Re: Professional Engineer's Certification of Permanent Control Measure
Flying Horse North Filing No. 4, Pond C

This letter serves as a Pond Certification for the constructed Full Spectrum Detention Facility "Pond C" located in Flying Horse North Filing No. 4. The permanent control measure is located at the central east area of the subdivision, adjacent and north of Old Stagecoach Road, east of Fringe Place and west of Rubble Drive.

Basin ID: **POND C**

DETENTION BASIN OUTLET STRUCTURE DESIGN

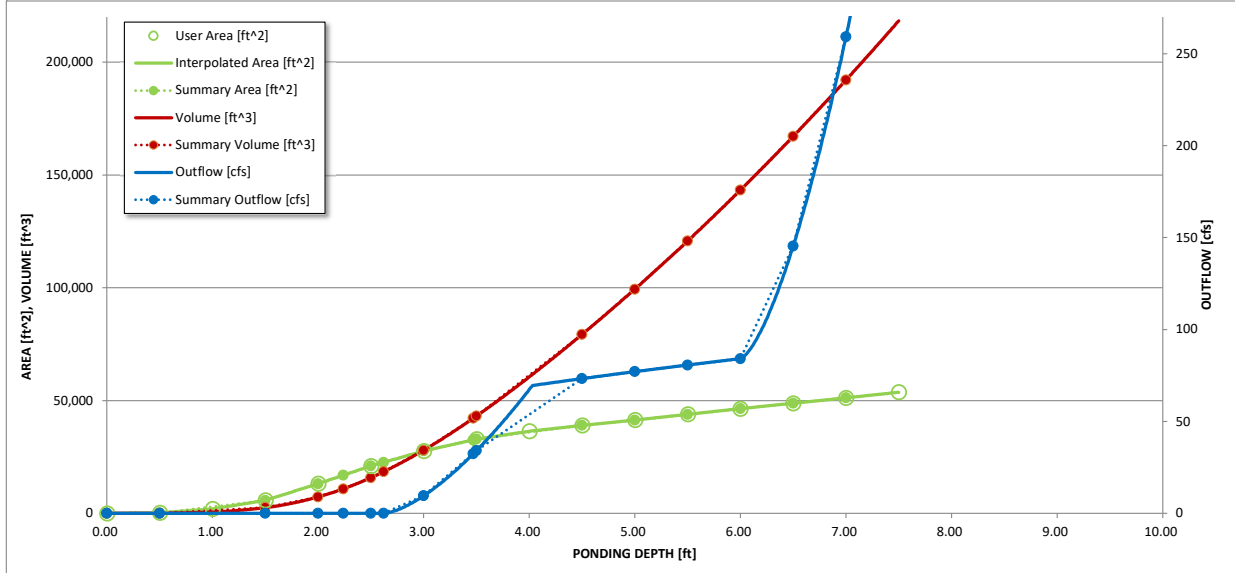
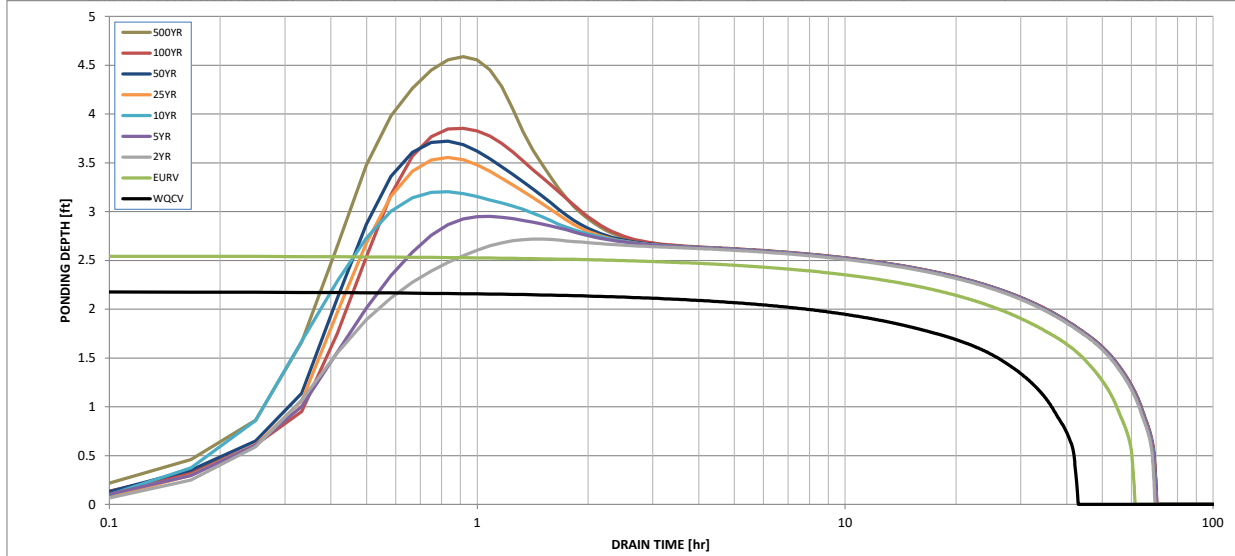
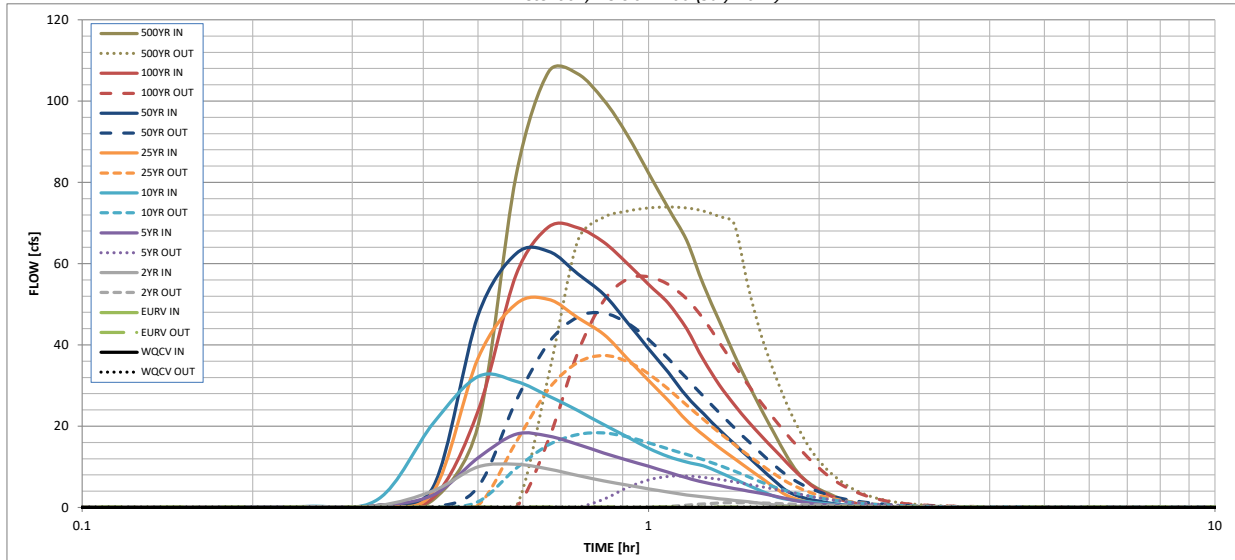
clearly label this as:
"Pond C - As-Built Conditions"
